## AMENDMENTS TO THE DRAWINGS

The attached sheets of drawings includes proposed changes to Figs. 1 and 3. These sheets replace the original sheets.

FIG. 1

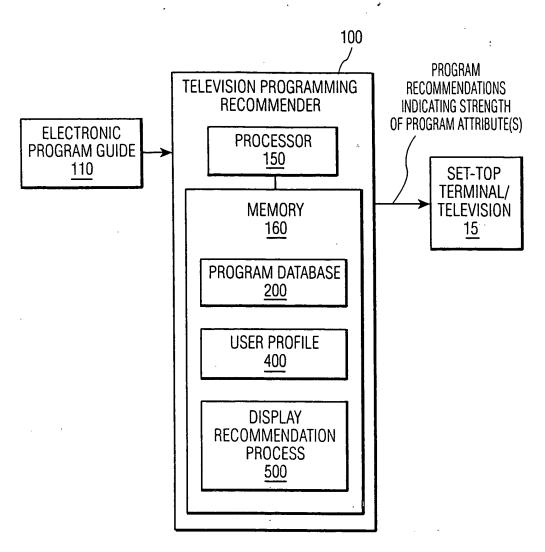
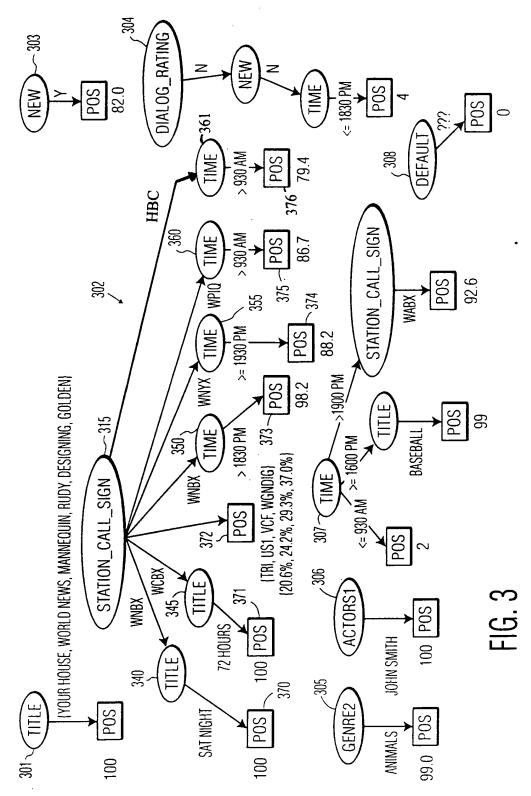
In the replacement sheet for Fig. 1, the set-top terminal/television has been re-numbered with reference number 15.

A corresponding amendment has been made to the specification.
